**Private Owner
Circular Letter
650 Issue 1b**

**Modification to
Y25 Bogie Clasp
Brake 'Banana'
Link**

Figure 1 Adjustment of brake rigging to suit the wheel diameter

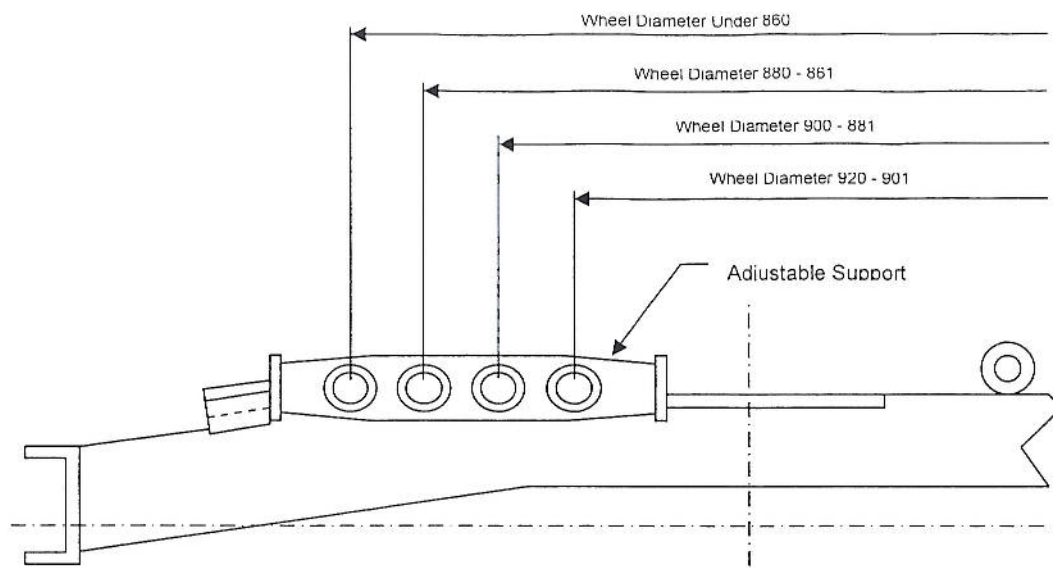
- Examine for damage and measure/gauge the brake rigging i.e. shafts, levers, links rods, pins and bushes for signs of excessive wear. Replace any components found to be outside of limits and the lubricate pins and bushes as required.
- Adjust the brake rigging to suit the wheel diameter by ensuring that the correct hole in the adjustment support is used (see Figure 1).
